SUBJECT: NuScale Power, LLC Supplemental Response to NRC Request for Additional Information No. 282 (eRAI No. 9196) on the NuScale Design Certification Application

NuScale Supplemental Response to NRC Request for Additional Information eRAI No. 9196

NRC Question No.: 19-36

Figure 9.3.4-1: Chemical and Volume Control System Diagram

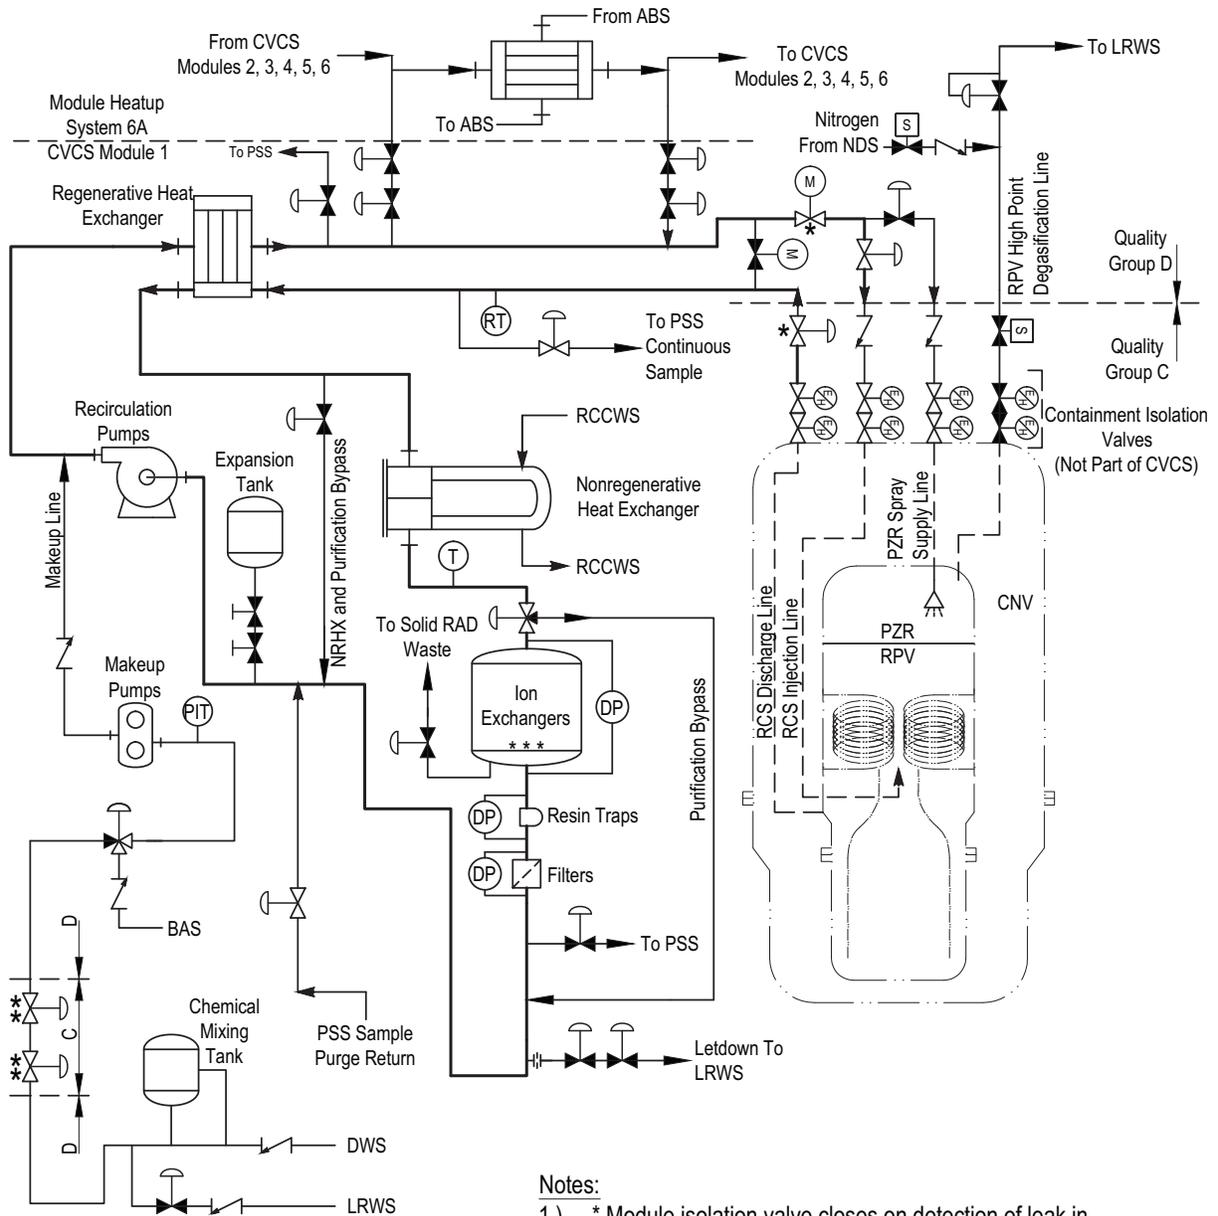
The information in FSAR Section 9.3.4 indicates that CVCS subsystems may not meet the guidance in SECY-93-087. FSAR Table 9.3.4-1 lists 150 psig as the design pressure for the CVCS Chemical Mixing Tank and the CVCS Expansion Tank.

The information in FSAR Section 9.3.4 indicates that CVCS connecting systems (i.e., systems that are connected to the RCS via the CVCS) may not meet the guidance in SECY-93-087. CVCS connecting systems (e.g., liquid radioactive waste system, demineralized water system, process sampling system, boron addition system) are shown in Figure 9.3.4-1. FSAR Table 9.3.4-2 lists 125 psig and atmospheric pressure as the design pressure for two of the components in the boron addition system which is a CVCS connecting system.

FSAR Figure 9.3.4-1 has been revised to include the pressure indicating transmitters on the suction of each of the CVCS makeup pumps. The figure has also been revised to show the check valve that is provided between the makeup pumps' discharge and the injection tee into the recirculation loop.

FSAR Section 9.3.4.3 and Figure 9.3.4-1 have been revised as described in the response

NuScale design. The CVCS containment isolation valves meet the SECY-93-087 recommendations for pressure isolation valves; position indication is provided to the control room and they have the capability for leak testing and are periodically leak tested as part of the Inservice Testing Program (FSAR Section 3.9.6). ~~The~~ Although intersystem LOCAs are prevented by the CVCS containment isolation valves, the CVCS is designed to withstand full RCS design pressure to the extent practicable. The CVCS recirculation loop, including the purification bypass line, are designed to withstand RCS design pressure. The CVCS letdown line and CVCS reactor vessel high point degasification line connections to the liquid radwaste system are designed to withstand full RCS design pressure up to the degasifier tank where design pressure is reduced and overpressure protection is provided. The process sampling system lines connected to the CVCS are designed to withstand full RCS design pressure. The makeup line and components upstream of the CVCS makeup pumps are the only portion of the CVCS that is not designed to withstand RCS design pressure. However, the CVCS makeup pumps are positive displacement type with integral check valves; in addition, a check valve is provided between the makeup pumps' discharge and the injection tee into the recirculation loop to minimize potential reactor coolant leak back to the low pressure portion of the CVCS makeup line. The CVCS design incorporates pressure and level alarms that provide the control room with indication of adverse conditions. For example, in the event of reactor coolant leakage past the makeup pumps, the pressure indicating transmitter at the suction of the makeup pump provides a high pressure alarm in the MCR.
